Appendix A

Review of FAI/08-70, "Gas-Voids Pressure Pulsations Program" (Reference 16)

Figure 2-3: Simplified view of the gas compression by a water column.

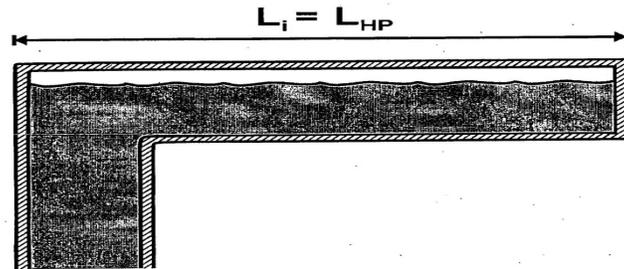
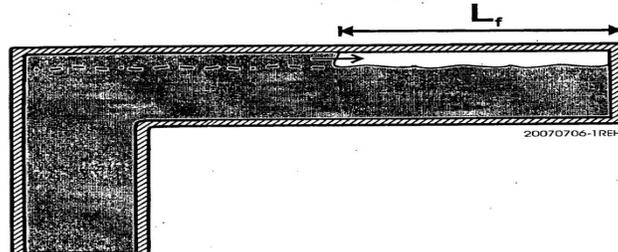
¹ The report contains inconsistent nomenclature and Equation 2-5 contains a typo. This unnecessarily complicates understanding of the modeling.

We note that Q, the pump flow rate at the fully run-up condition, is not given in the report and inconsistent values are given for pump shutoff head. Consequently, it is not possible to straightforwardly compare test data to model predictions. We did not attempt to calculate model predictions in order to obtain comparisons.

Figure B-1: Peak Air-Water Waterhammer Force versus Water Volume Drained: Data and Calculations with Analytical Model.

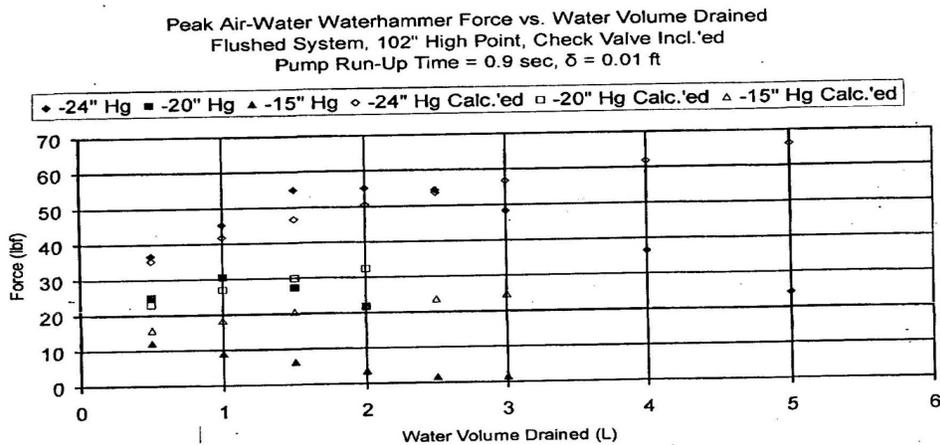
At smaller initial void fractions the test results are under-predicted by the model by about 20 percent and over-predicted by about a factor of three. The model over-predicts the test data for higher initial void fractions. We note that the results are hardware-specific and different configurations will result in different forces. This aspect of the modeling is not quantitatively addressed nor supported with other experimental data.

Figure 5-5: Terminal velocity of air bubbles in filtered or distilled water as function of bubble size (taken from Wallis, 1969).

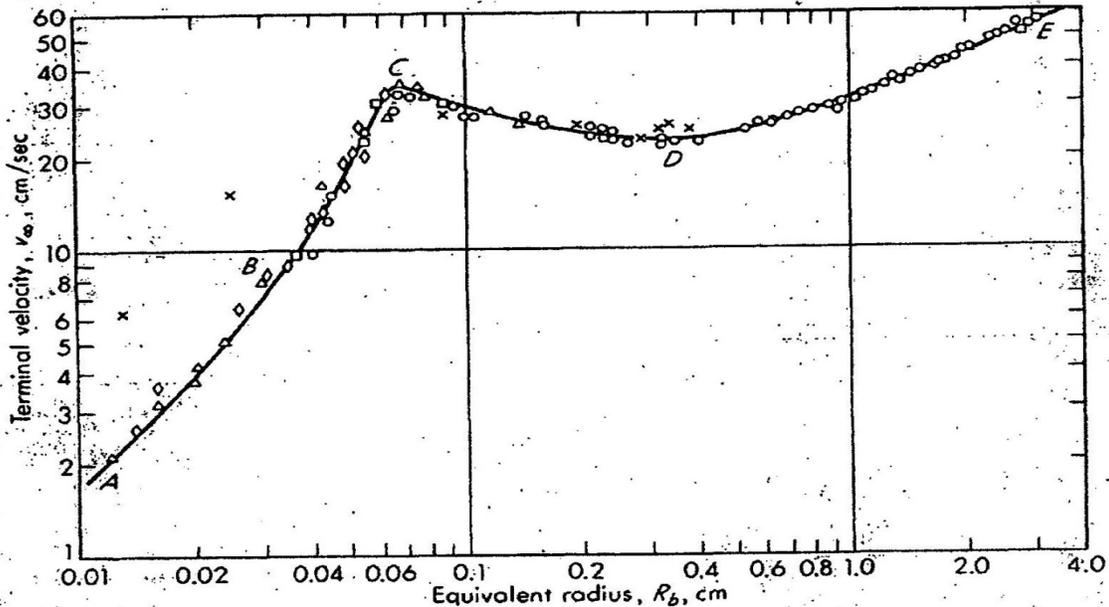
The discussion of "wash-out" of gas as a function of Froude number is oversimplified and could be mis-applied when considering in-plant behavior because the FAI/08-70 "wash-out" tests apply only to horizontal pipes that do not have local high points where gas can accumulate. This is in part illustrated by the Reference A-2 information where FAI/08-70 states that "Wallis et

al (1977) (Reference A-2) performed tests on the liquid velocity that is sufficient to "washout" a gas bubble at the discharge of the pipe into a large reservoir. This resulted in a criterion of a Froude number equal to 0.54 as being sufficient to "washout" the gas volume...." A summary of Reference A-2 stated that "The data for horizontal tubes were successfully correlated with some simple limiting theories and dimensionless representations. The vertical tube results were influenced by stability phenomena and nonsymmetrical flow patterns; as a result only a partial understanding was obtained." Further, the Wallis conclusion is consistent with Purdue test results during downward flow in a vertical pipe that then connected to a horizontal pipe. Gas was observed to accumulate in the lower part of the vertical pipe and the connected lower horizontal pipe and then moved up the vertical pipe despite downward flow at Froude numbers greater than 0.54.

The above information justifies assuming that flow in a horizontal pipe that has no local high points will move any gas toward the downstream end of the pipe when the Froude number is greater than 0.54. The 0.54 criterion cannot be applied to the downstream end of a horizontal pipe unless gas can flow freely from the end of the pipe.
